Date: Feb 27, 2001

To: T10 Committee (SCSI)

Subject: Defining Targets/Initiators as Ports

The following show the changes in SAM-2 that would be required to change to support a port = target/initiator model.

**Figure 6 — Initiator hierarchy diagram**

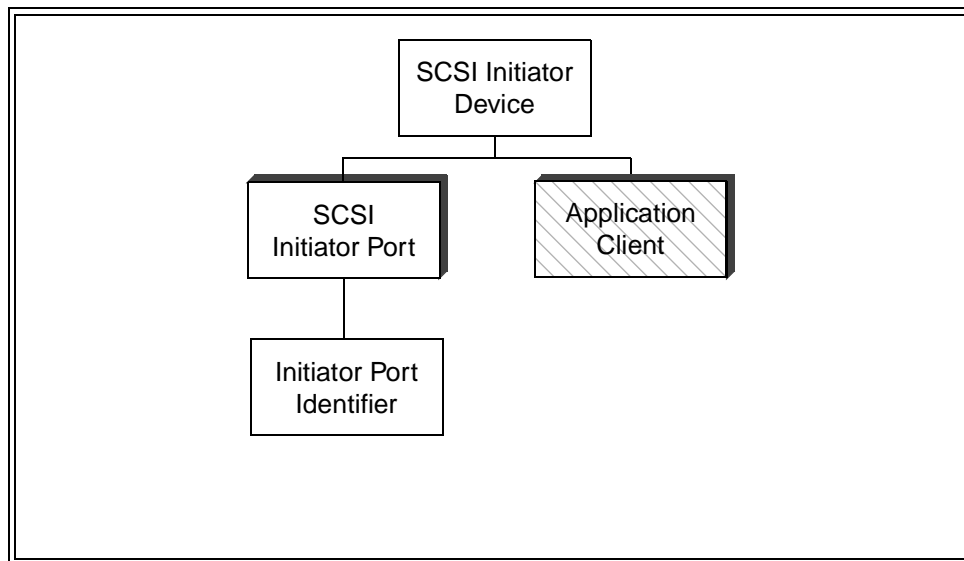
A SCSI initiator device (see figure 6) contains:

- a) one more SCSI initiator ports each containing an initiator port identifier; and
- b) zero or more application clients.

**Figure 7 — Target hierarchy diagram**

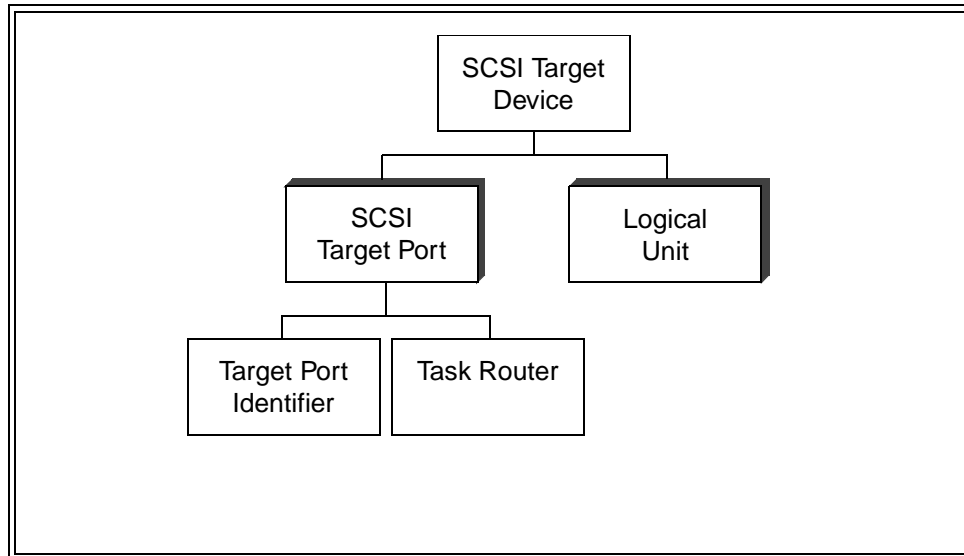
A SCSI target device (see figure 7) contains:

- a) one more SCSI target ports each containing a task router and SCSI target port identifier; and
- b) one or more logical units.

**Figure 8 — Target/Initiator hierarchy diagram**

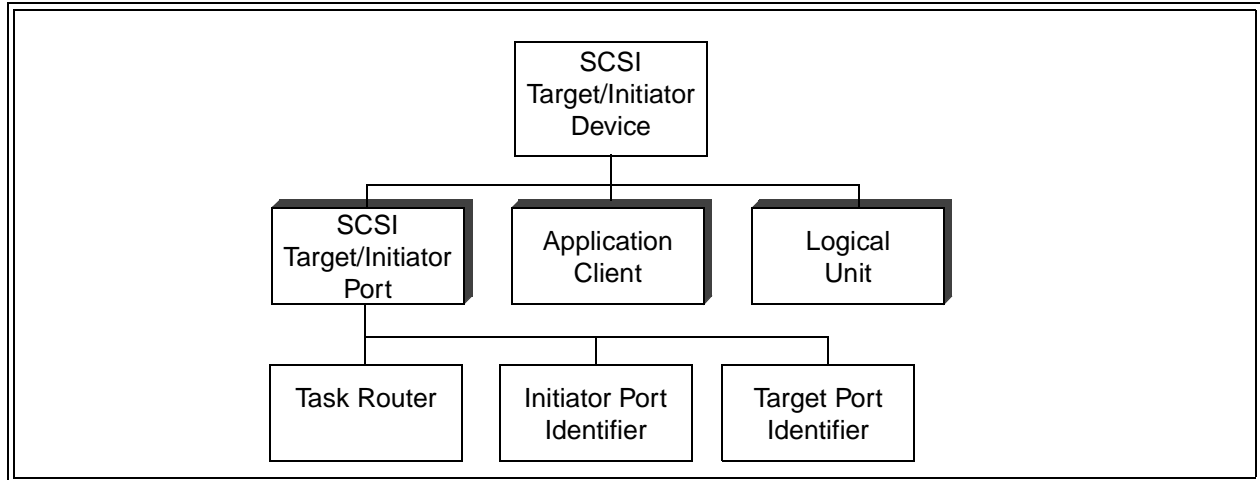
A SCSI target/initiator device (see figure 7) contains:

- a) one or more SCSI target/initiator ports each containing a task router, target port identifier, and an initiator port identifier;
- b) one or more logical units; and
- c) zero or more application clients.

The target port identifier and the initiator port identifier are values containing a SCSI identifier for a SCSI target/initiator port. The target port identifier and the initiator port identifier may or may not be identical.

Figure 10 — SCSI device functional models

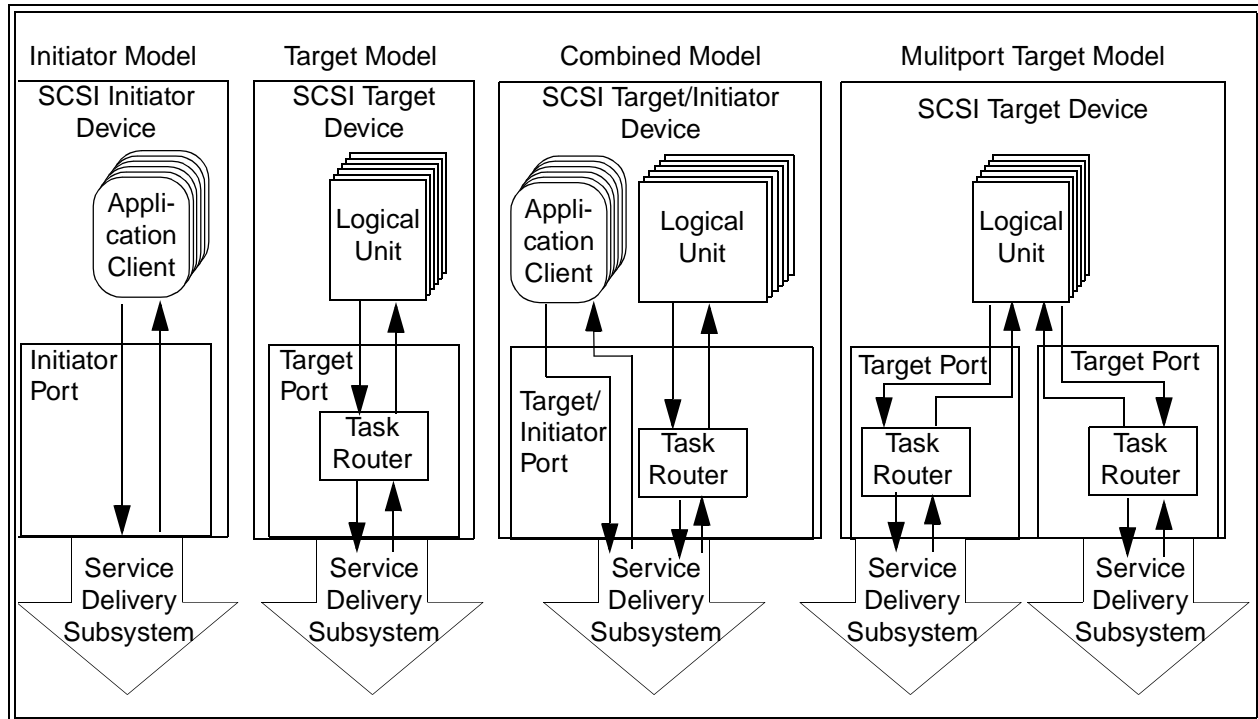
A SCSI device may contain only SCSI target ports, only SCSI initiator ports, only SCSI target/initiator ports or any combination of ports. Some of the port configurations possible for a SCSI device are shown in figure 10.

A target/initiator SCSI device is referred to by the role its port takes when it participates in an I/O operation. When a SCSI target/initiator device receives SCSI commands or task management functions, the SCSI target/initiator device takes on the characteristics of and is referred to as a SCSI target device. When a SCSI target/initiator device issues SCSI commands or task management functions, the SCSI target/initiator device takes on the characteristics of and is referred to as a SCSI initiator device.

**Figure 11 — Multiple port target SCSI device structure model**

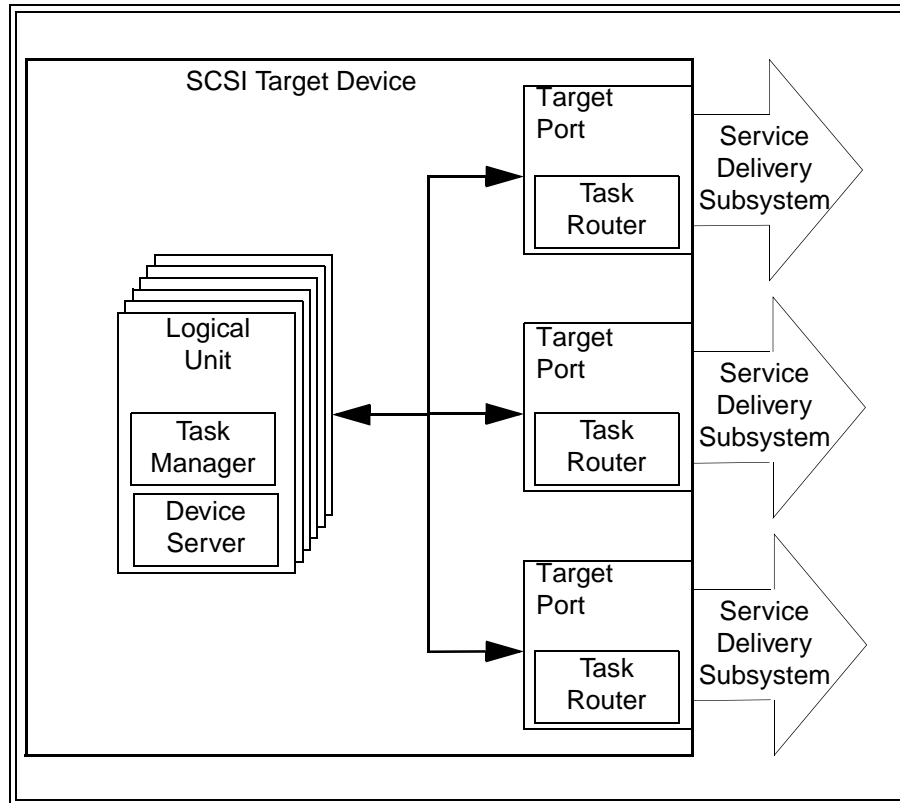
Figure 11 shows the structure of a SCSI target device with multiple SCSI target ports. Each SCSI target port consists of a task router that is shared by a collection of logical units. Each logical unit contains a single task manager and a device server.

Two-way communications shall be possible between all logical units and all SCSI target ports, however, communications between any logical unit and any SCSI target port may occasionally be inactive. Two-way communications shall be available between each task manager and all task routers. Each SCSI target port shall accept commands addressed to LUN 0 and the task router shall route them to a device server for processing. The REPORT LUNS commands (see SPC-2) shall be accepted by logical unit 0 from any SCSI target port and shall return the logical unit inventory available via that SCSI target port. The availability of the same logical unit through multiple SCSI target ports is discovered by matching SCSI port identifier values in the INQUIRY command vital product data page (see SPC-2).

**Figure 12 — Multiple port SCSI initiator device structure model**

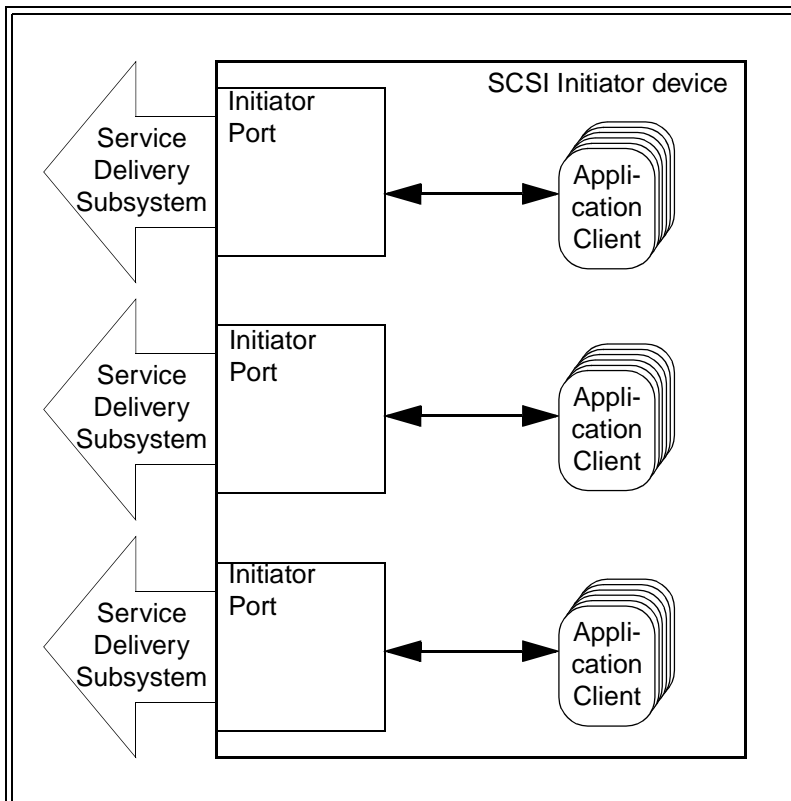
Figure 11 shows the structure of a SCSI initiator device with multiple SCSI initiator ports. Each SCSI initiator port is shared by a collection of application clients.

Two-way communications shall be possible between an application client and its associated SCSI initiator port. Mechanisms by which a SCSI target device would have the ability to discover that it is communicating with multiple ports on a single SCSI initiator device are beyond the scope of any standards in the SCSI family of standards.

**Figure 13 — Multiple port target/initiator SCSI device structure model**

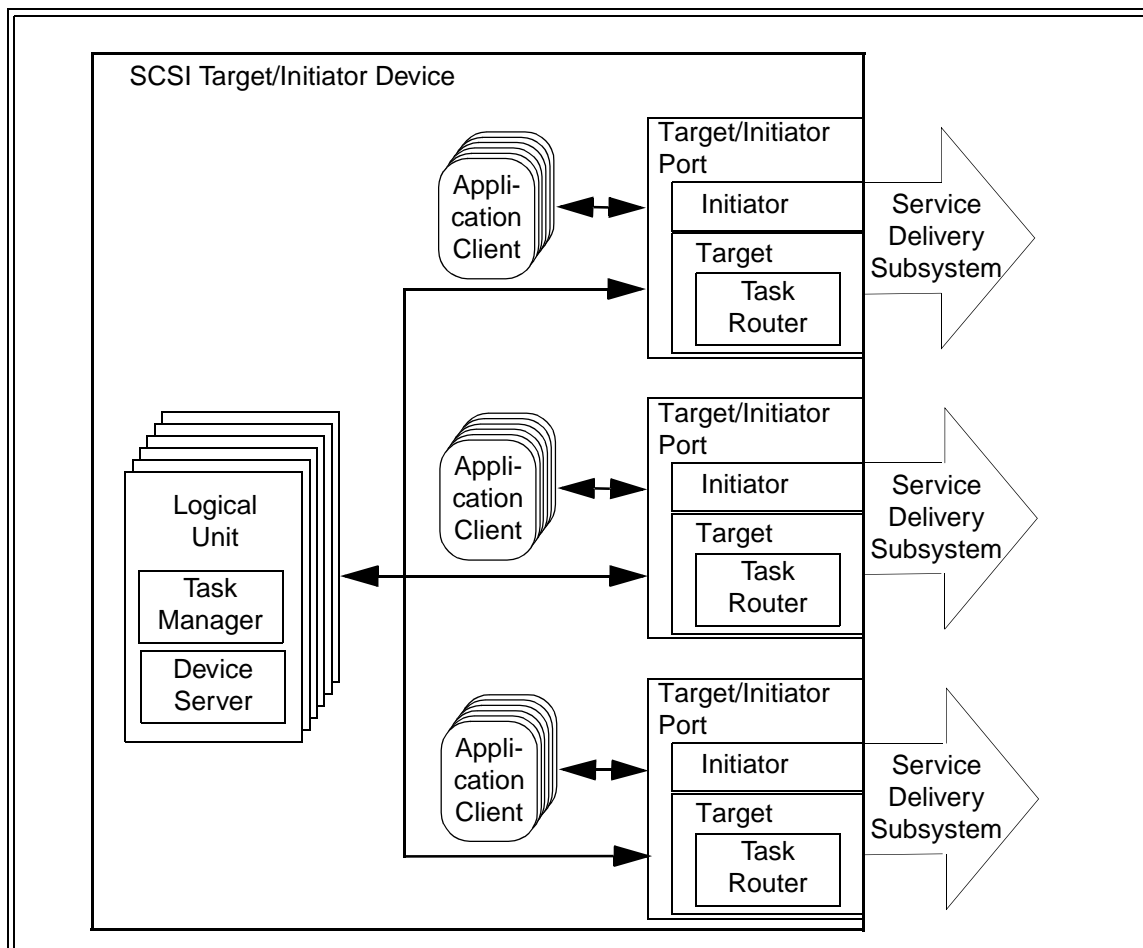
Figure 11 shows the structure of a SCSI target/initiator device with multiple SCSI target/initiator ports. Each SCSI target/initiator port consists of a task router and is shared by a collection of logical units and application clients. Each logical unit contains a single task manager and a device server.

Two-way communications shall be possible between all logical units and all SCSI target/initiator ports, however, communications between any logical unit and any SCSI target/initiator port may occasionally be inactive. Two-way communications shall be possible between an application client and its associated SCSI target/initiator port. Each SCSI target/initiator port shall accept commands addressed to LUN 0 and the task router shall route them to a device server for processing. The REPORT LUNS commands (see SPC-2) shall be accepted by logical unit 0 from any SCSI target/initiator port and shall return the logical unit inventory available via that SCSI target/initiator port. The availability of the same logical unit through multiple SCSI target/initiator ports is discovered by matching SCSI port identifier values in the INQUIRY command vital product data page (see SPC-2).

**Figure 14 — SCSI target device configured in a single SCSI Domain**

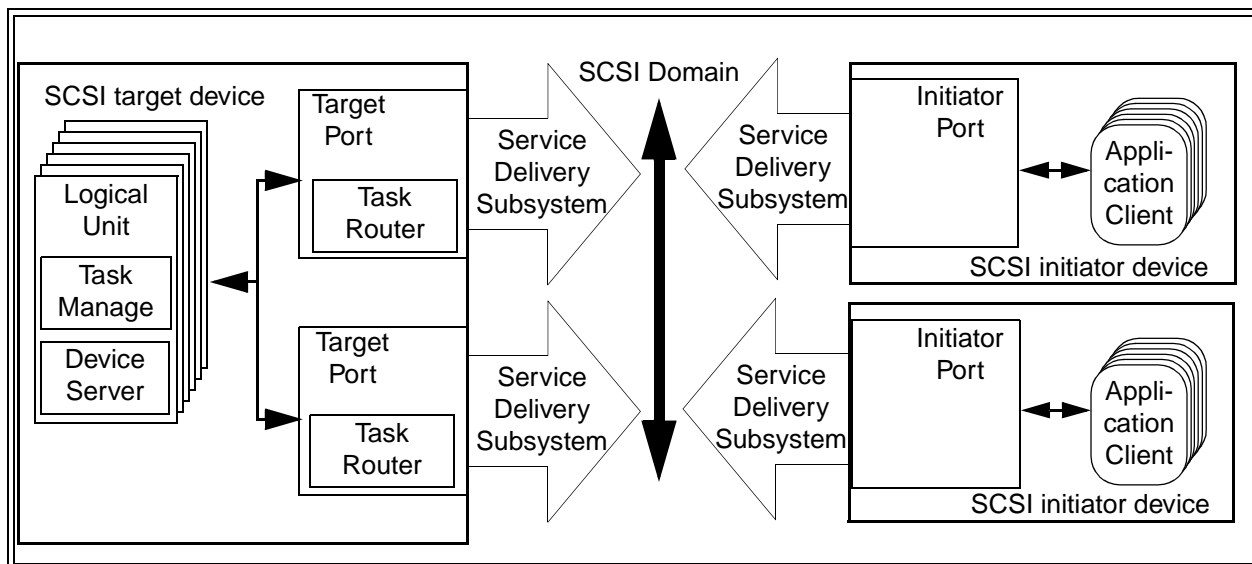
Figure 14 shows a SCSI target device with multiple SCSI target ports participating in a single SCSI domain with two SCSI initiator devices. There are three SCSI devices, one of which has two SCSI target ports, one with one SCSI initiator port, and one with one SCSI initiator port. There are two SCSI target port identifiers and two initiator port identifiers in this SCSI domain. Using the INQUIRY command vital product data page (see SPC-2), the application clients in each of the SCSI initiator devices have the ability to discover the logical units in the SCSI target devices are accessible via multiple SCSI target port identifiers (i.e., SCSI target ports) and map the configuration of the SCSI target devices.

**Figure 15 — SCSI target device configured in multiple SCSI Domains**

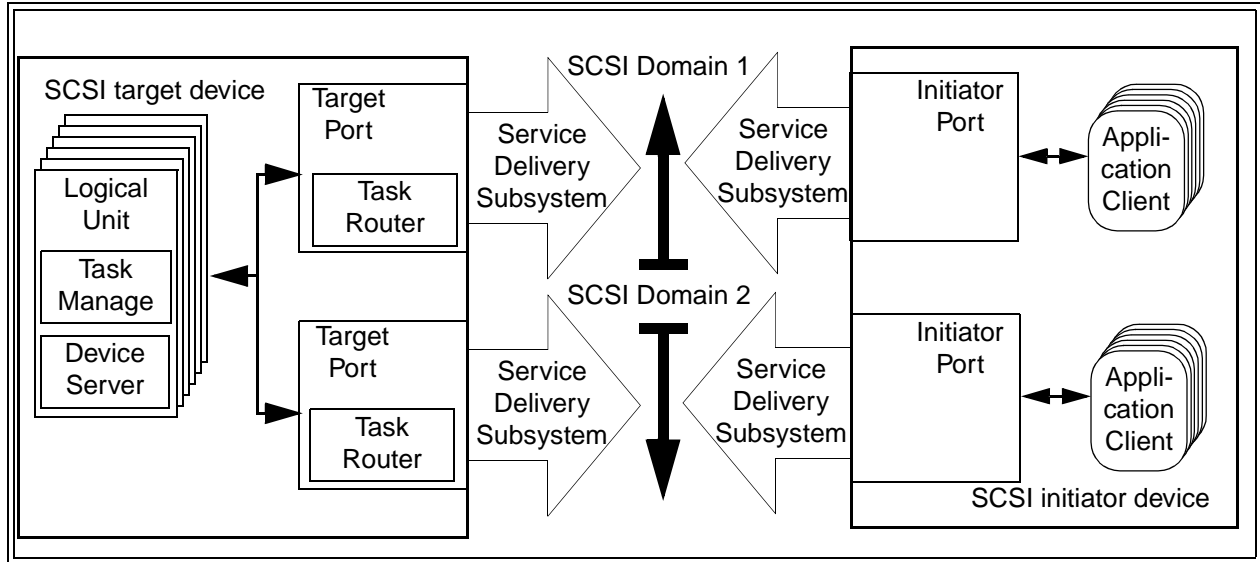
Figure 15 shows a SCSI target device with multiple SCSI target ports participating in two SCSI domains and a SCSI initiator device with multiple SCSI initiator ports participating in the same two SCSI domains. There is one SCSI target device with two SCSI target ports and one SCSI initiator device with two SCSI initiator ports. There is one SCSI target port identifier and one initiator port identifier in each of the two SCSI domains. Using the INQUIRY command vital product data page (see SPC-2), the application clients in the SCSI initiator device have the ability to discover that logical units in the SCSI target device are accessible via multiple ports and map the configuration. However, the methods available to application clients to distinguish between the configuration shown in figure 15 and the configuration shown in figure 22 may be beyond the scope of the SCSI family of standards.

**Figure 16 — SCSI target device and SCSI initiator device configured in a single SCSI Domain**

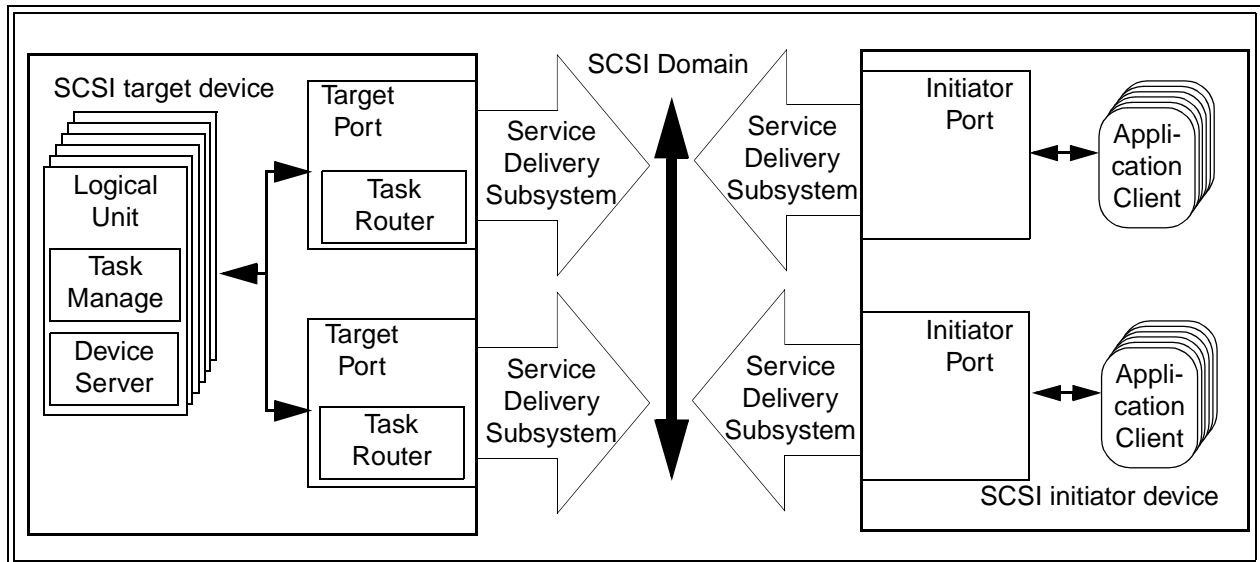
Figure 16 shows the same configuration as figure 15 except that the two SCSI domains have been replaced by a single SCSI domain.
